EVALUATION OF DOD WASTE SITE GROUNDWATER
PUMP-AND-TREAT OPERATIONS

Report Number 98-090

March 12, 1998

SUBJECT: Evaluation Report on DoD Waste Site Groundwater Pump-and-Treat
Operations (Report No. 98-090)

Figure 2: Total Annual Operations and Maintenance Plus Monitoring Costs

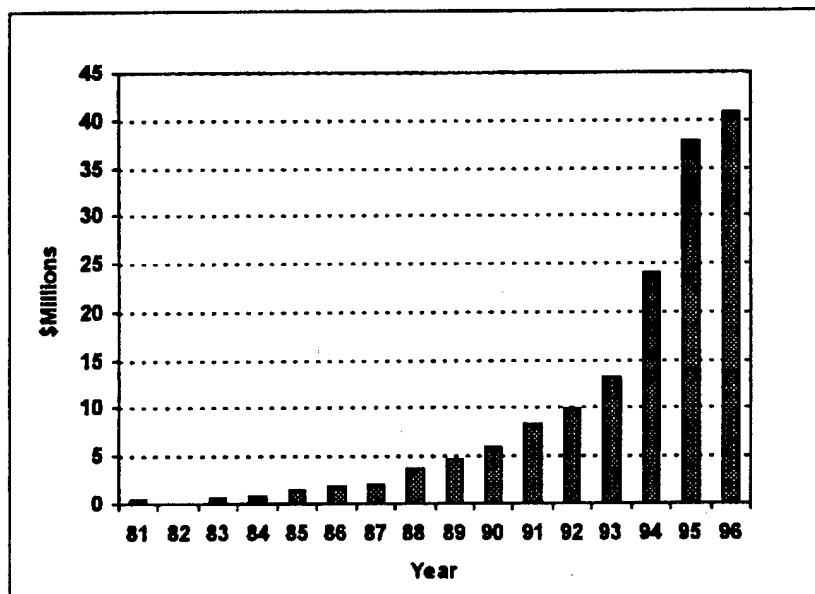
r. Page 10, first paragraph, last sentence. The conclusion reached in this sentence does not necessarily follow from the figure below it. The total costs presented in Figure 2 are a function of the total number of systems in operation. Much of the increase in O&M costs after 1994 is the result of 24 additional systems being brought online in 1995 and 1996. Therefore it is misleading to imply that O&M costs will continue to increase at the same rate as that shown in the figure when the number of new pump and treat systems is declining (only 7 systems brought online in 1996 compared to 17 systems in 1995).
